**2026 Glenwood Tank Site Projects:
Site Improvements (Secant Wall Installation)**

ADDENDUM NO. 3

The following clarifications and revisions are hereby incorporated in the Contract Documents, Construction Specifications and Plans for the project entitled, *"Glenwood Tank Site Project – Site Improvements (Secant Wall Installation), Scotts Valley Water District"*:

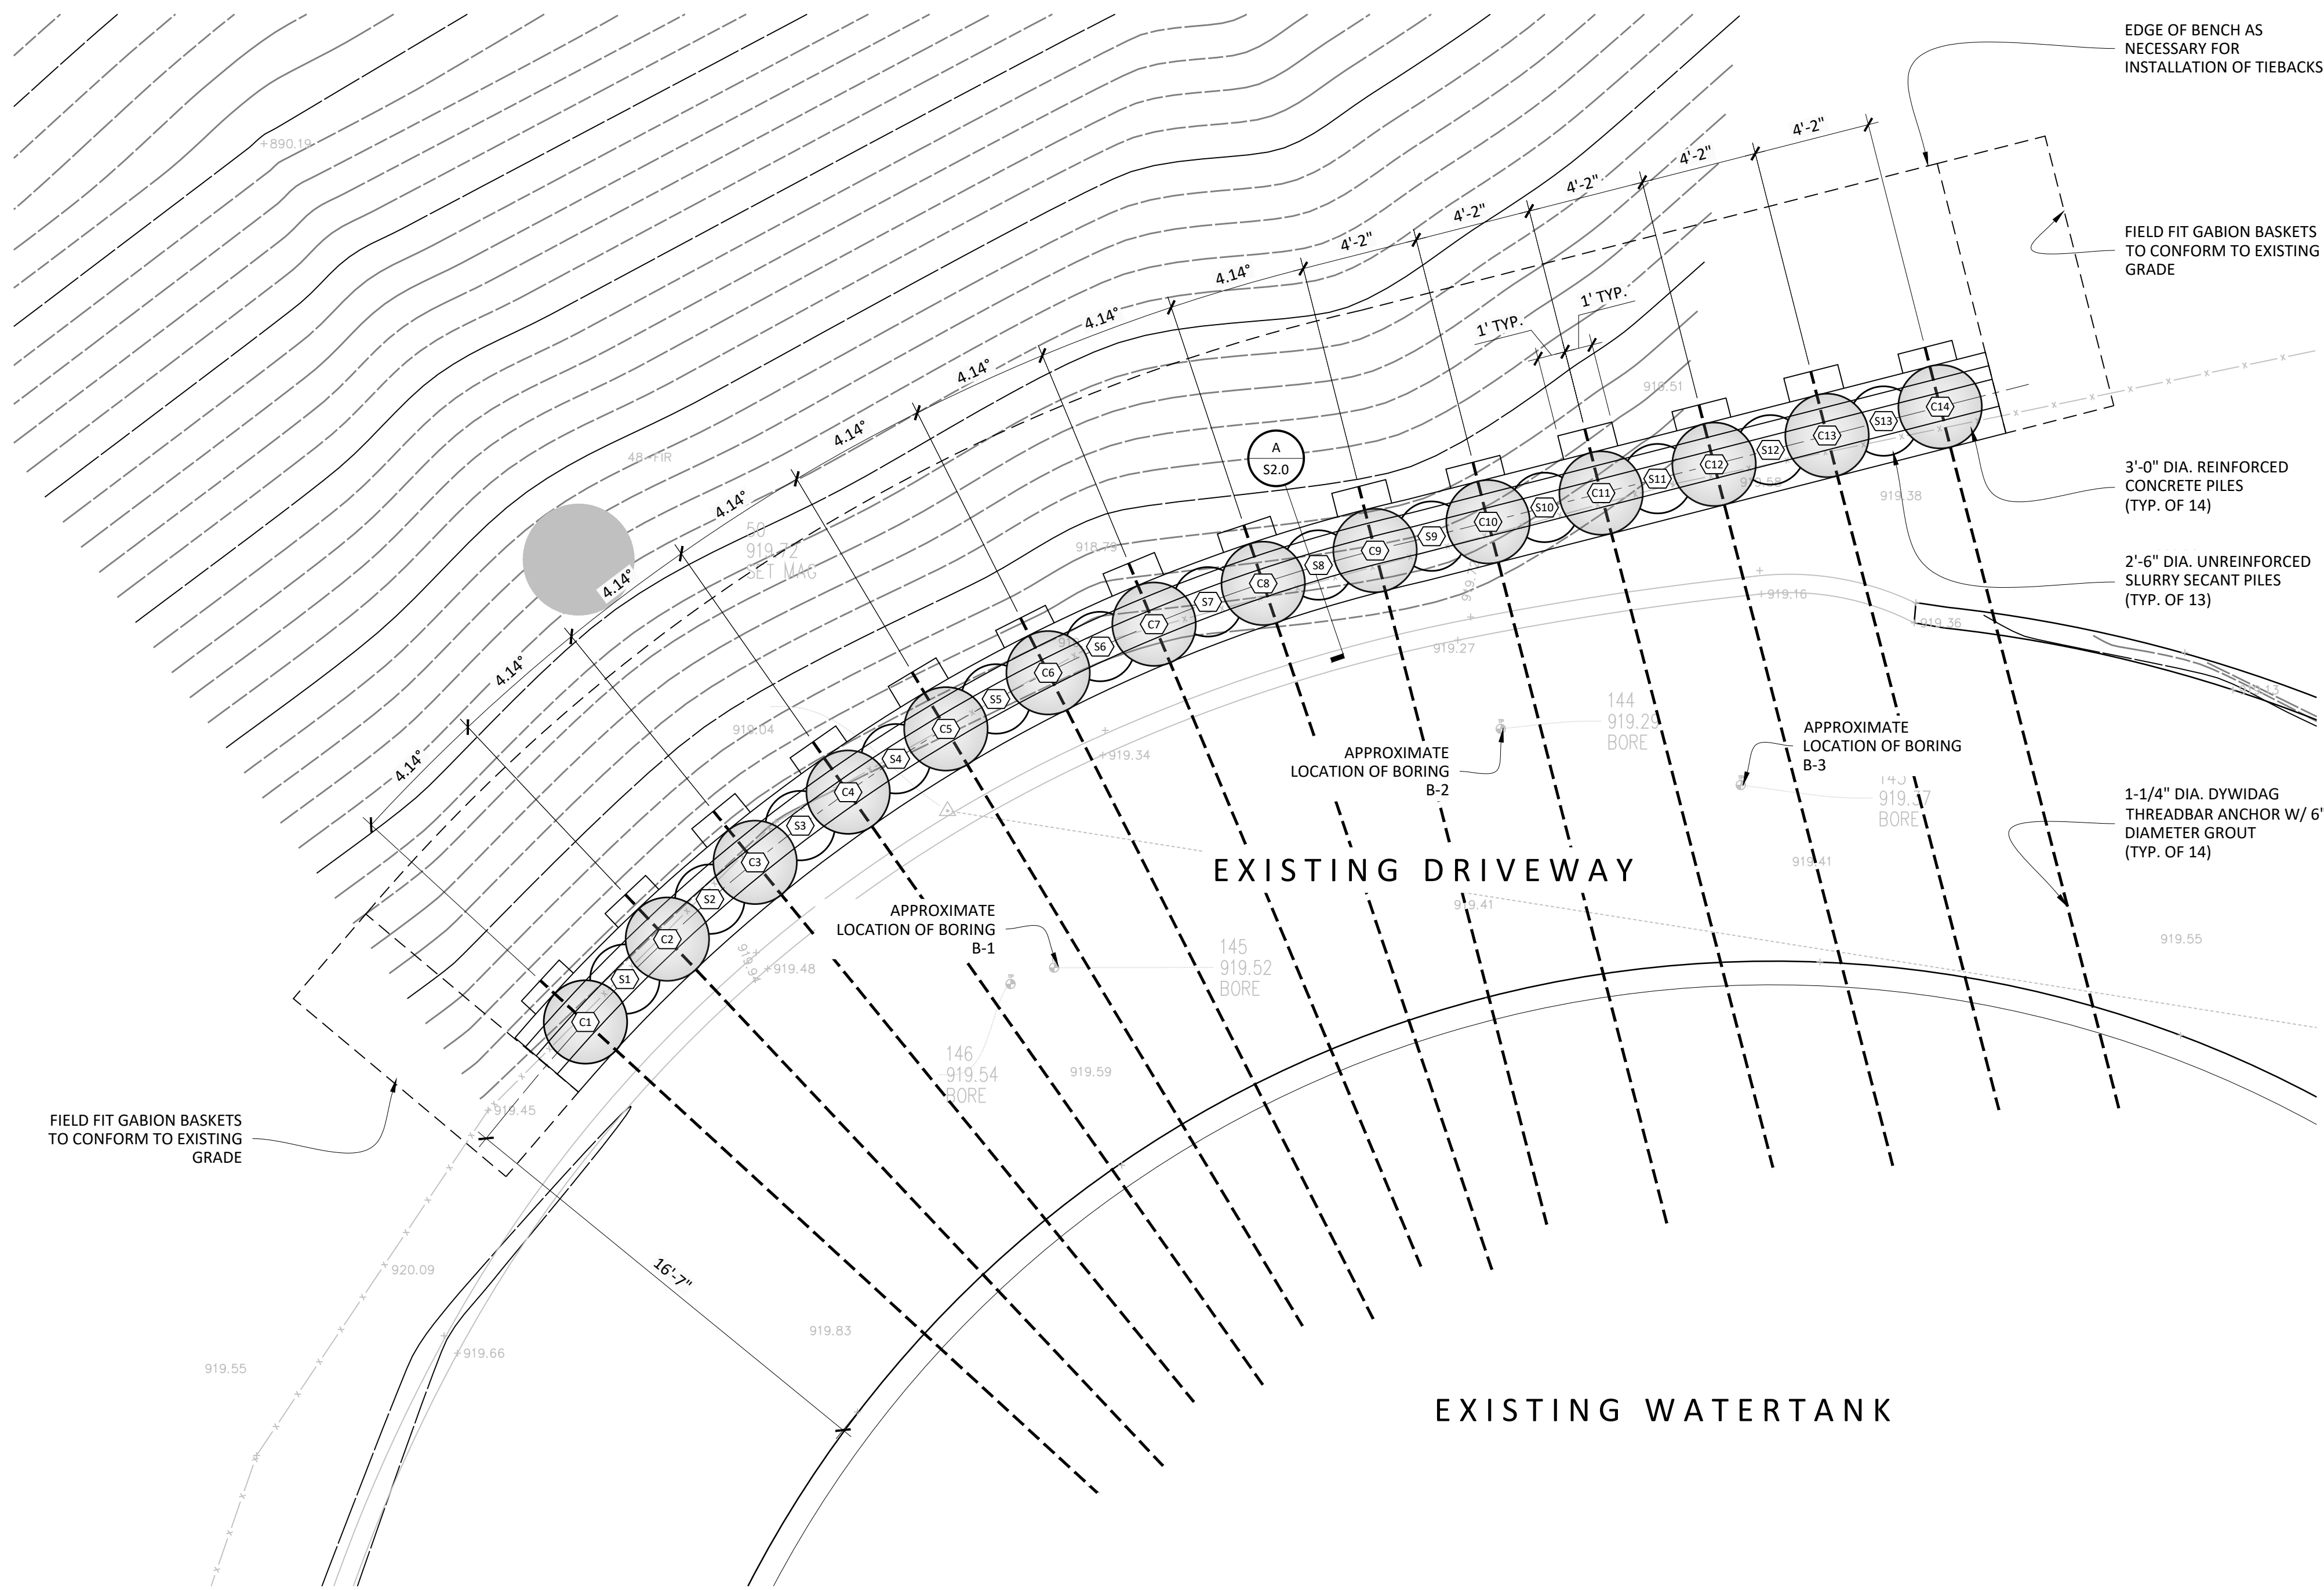
Q: Note J.5/S0.0 states "Install Grade Beam. Install and test tiebacks per the installation procedures on this sheet." Is there a specific strength that the tiebeam concrete must reach prior to performing tieback testing? This can affect project schedule durations.

A: Tieback testing shall not be performed until the tiebeam concrete has achieved a minimum compressive strength of 75% of the specified design compressive strength, f'_c , as verified by field-cured cylinder testing or other approved strength testing.
